TOWN OF MILFORD, NH
OFFICE OF COMMUNITY DEVELOPMENT

Date: October 11, 2022
To: Planning Board
From: Camille Pattison, NRPC Assistant Director
Subject: SP2022-08 Sooner Transportation LLC, for the property located at Tax Map 12, Lot 11, 754-756 Elm Street (Horseless Carriage Site). Public Hearing for a Major Site Plan Application to construct a two-story, 10,320 sf. auto sales and repair facility with associated parking, stormwater management/drainage, landscaping, and lighting improvements on the subject property located in the Commercial ‘C’ Zoning District and West Elm Overlay District.

**Re: Sooner Milford Site Plan (Tax Map 12, Lot 11) – 754 and 756 Elm Street
Site Plan Drainage Review**

SOONER MILFORD SITE PLAN

TAX MAP 12 LOT 11

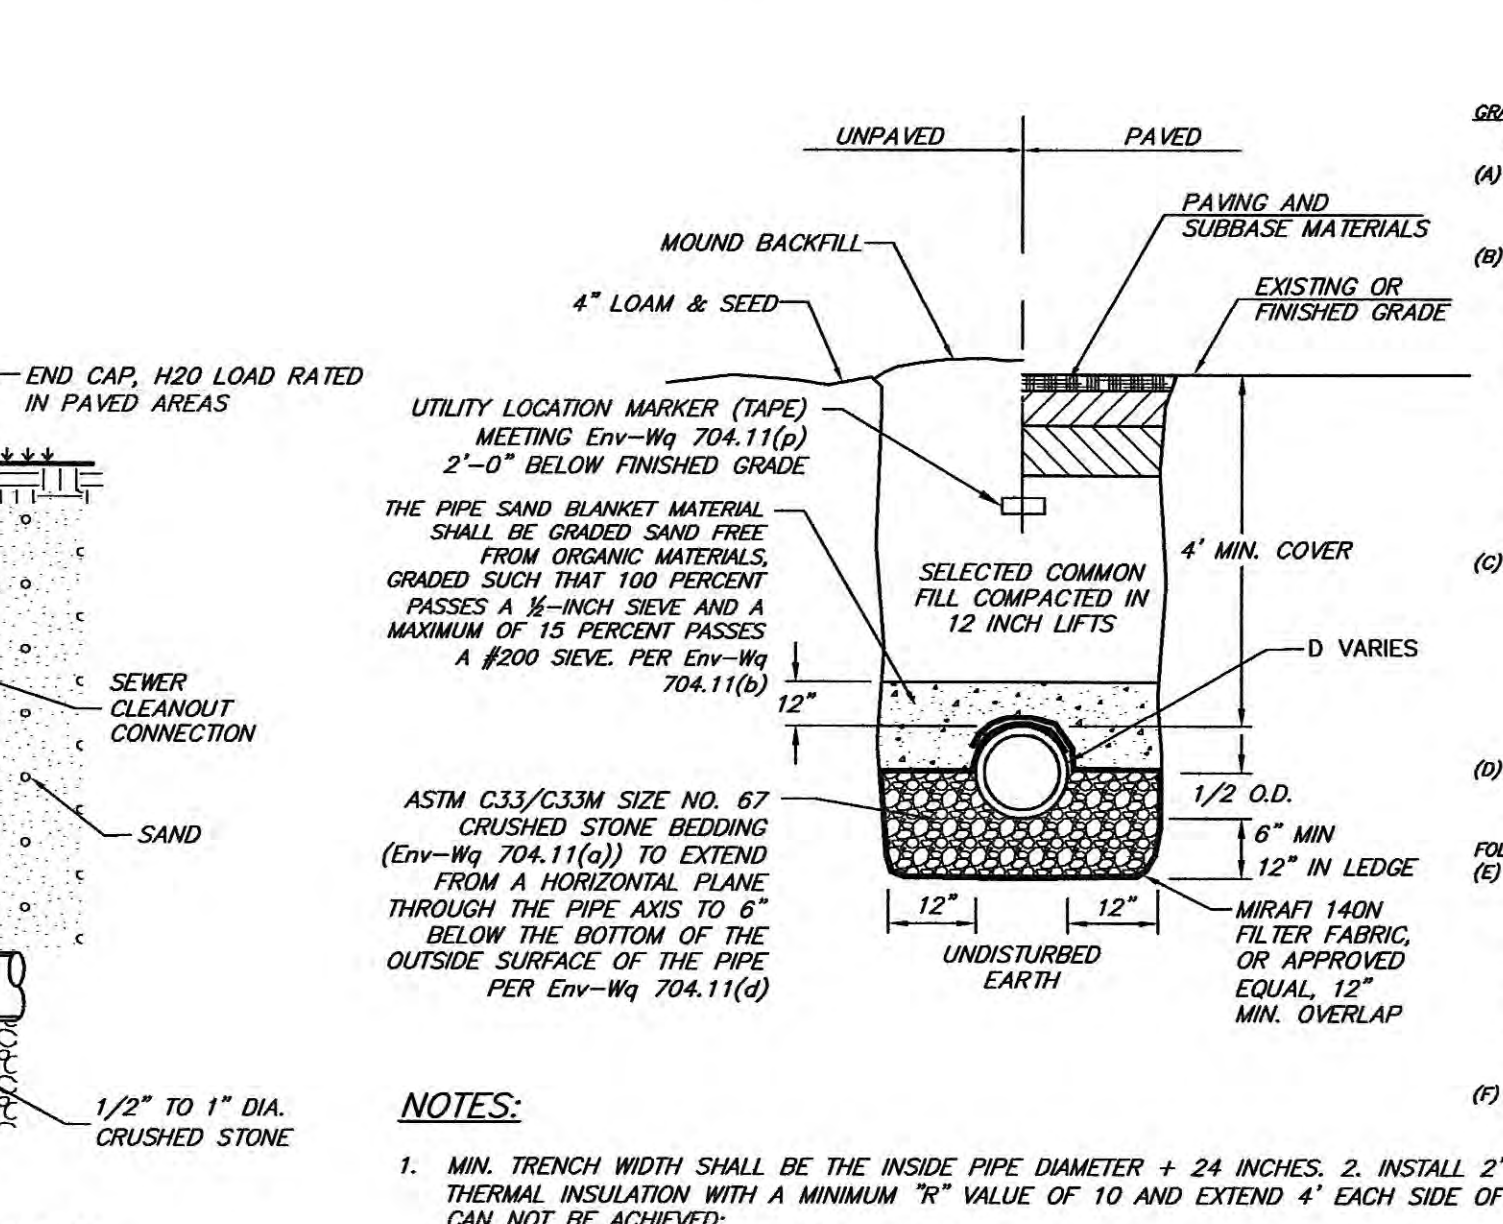
9. Please revise site plan to include all proposed signage for the project. *Resolved*
10. Sheets 1 and 10 – The site plan shows the proposed location of the dumpster and pad encircled by an 8' stockade fence within the 15-foot westerly side dimensional setback. The proposed 8' stockade fence and concrete pad are defined as structures in the Town's Zoning Ordinance and such, would require a Special Exception by the Board of Adjustment for relief of this requirement. The alternative would be amending the plan and relocate the dumpster outside of the dimensional setback. *Resolved*

10. Sheets 1 and 10 – The site plan shows the proposed location of the dumpster and pad encircled by an 8' stockade fence within the 15 foot westerly side dimensional setback. The proposed 8' stockade fence and concrete pad are defined as structures in the Town's Zoning Ordinance and such, would require a Special Exception by the Board of Adjustment for relief of this requirement. The alternative would be amend the plan and relocate the dumpster outside of the dimensional setback.
